DEPARTMENT OF ENVIRONMENTAL PROTECTION  
DIVISION OF WATER MONITORING AND STANDARDS

ADOPTED AMENDMENT TO THE UPPER DELAWARE WATER QUALITY  
MANAGEMENT PLAN AND SUSSEX COUNTY WATER QUALITY MANAGEMENT  
PLAN

TO ADOPT FOUR TOTAL MAXIMUM DAILY LOADS FOR PHOSPHORUS IN THE  
PEQUEST RIVER WATERSHED, WATERSHED MANAGEMENT AREA 1,  
NORTHWEST WATER REGION, AS LISTED IN TABLE 1

### **Summary of Public Comments and the Department's Response**

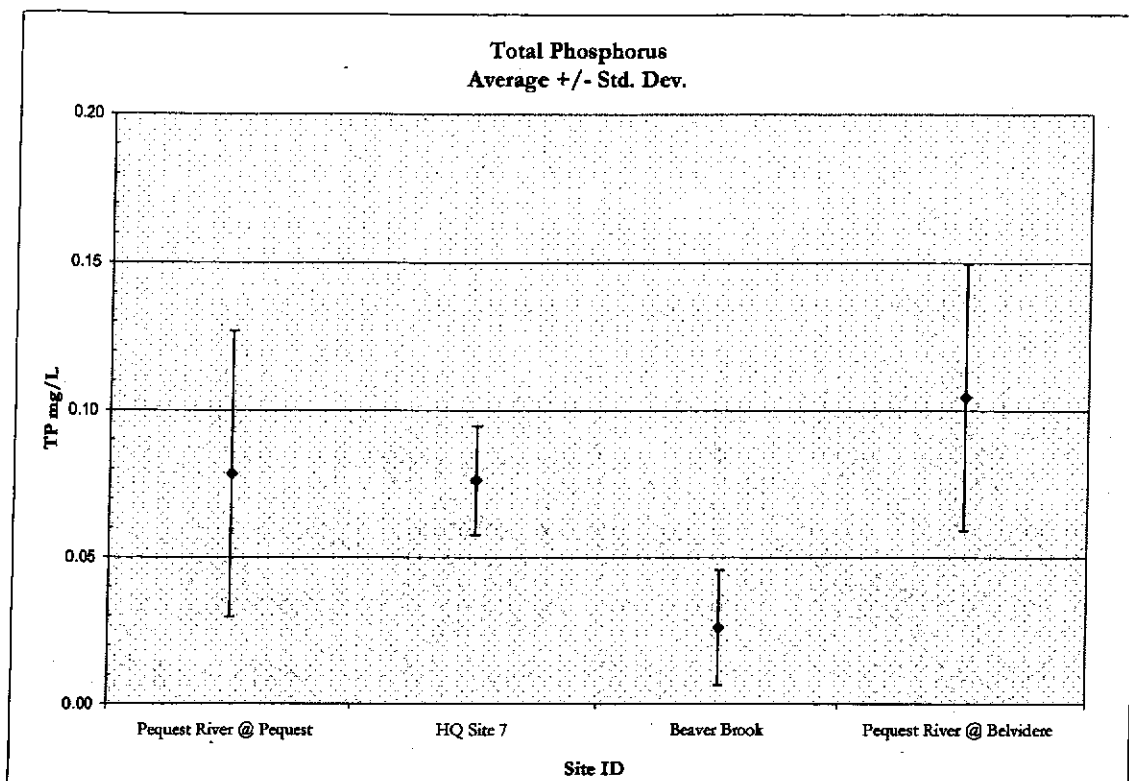
Comment 3: The TMDL is incomplete in that it does not include all total phosphorus impaired waters within the Pequest River watershed. Only 4 out of 5 Assessment Units were addressed. Given the available data, a comprehensive total phosphorus TMDL including all of the total phosphorus impaired Assessment Units appears feasible. The costs for additional data collection may be placed on the Warren County Municipal Utilities Authority. Additionally, the TMDL for the remaining Assessment Unit might result in a more stringent WLA and effluent limits, when it is complete. A more practical procedure would be to complete the TMDL study for the entire Pequest River rather than proceed with the piecemeal approach that the proposed total phosphorus TMDL represents. Based on the amount of available data for the Assessment Unit, there needs to be a credible reason, aside from "needs additional study", to explain why all of the impaired Assessment Units have not been addressed. (2)

Response to Comments 2 and 3: The statement in the TMDL that additional study is required to address the "Pequest River below Furnace Brook (02040105090060-01)" Assessment Unit was based on an evaluation of water quality data sampled within and at the boundary of this assessment unit. The Department found that the data collected to date is insufficient to properly characterize all sources within this assessment unit.

Total phosphorus data was collected under low flow conditions, defined as that flow which is exceeded 70% of the time, at several locations: Pequest River at Pequest (USGS station ID 01445500) located at the boundary of this assessment unit (AU), HydroQual Site 7, Beaver Brook (USGS station ID 01445495), and the most downstream location: Pequest River at Belvidere (USGS station ID 01446400). The graph below shows the total phosphorus concentrations at the sites listed above. Because sampling was done during low flow conditions, storm driven loads can be ignored for this illustration. Starting from the left, with the most upstream location, the total phosphorus concentrations at Pequest River at Pequest were compared to the next downstream location, HydroQual Site 7, and the concentrations were found to be similar, with an average total phosphorus concentration of 0.078 mg/L and 0.076 mg/L, respectively.

Considering the distance of 4.5 miles between these two sites, attenuation of the phosphorus load should result in total phosphorus concentrations at HQ Site 7 that would be notably lower than those at the boundary of this assessment unit. This suggests that there is a source of total phosphorus between these two sites. Proceeding downstream, total phosphorus concentrations from Beaver Brook are quite low; many of the total phosphorus data are below the detection limit. Despite this dilution from a higher quality source, total phosphorus concentrations at Pequest River at Belvidere show an increase, with total phosphorus concentrations exceeding 0.1mg/L. This suggests, again, a source between the confluence of Pequest River and Beaver Brook and the Pequest River at Belvidere site.

The Department concluded that in order to address this remaining impaired assessment unit, additional sampling within this impaired assessment unit is needed to better understand and characterize the sources and the needed reductions. Any additional sampling required to address the remaining impaired assessment unit will not be the obligation of the Warren County MUA. It is not unique to this TMDL to have related downstream impaired assessment units deferred because of a need for further study or to address a downstream assessment unit separately from upstream assessment units. In this latter case, the Department assumes that criteria for the parameter of concern are met at the upstream boundary entering the assessment unit. Because TMDL implementation would attain SWQS, it is expected that no further reduction would be required in upstream areas, particularly since it appears that there is a significant uncharacterized source in the downstream impaired assessment unit. However, no guarantees can be given about future requirements as the Department will need to assess the effectiveness of the TMDL over time and may need to employ adaptive management principles to address lack of success. This could include assigning revised WLAs to upstream sources. In any case, upgrades at this time have value in that they are needed to restore water quality.
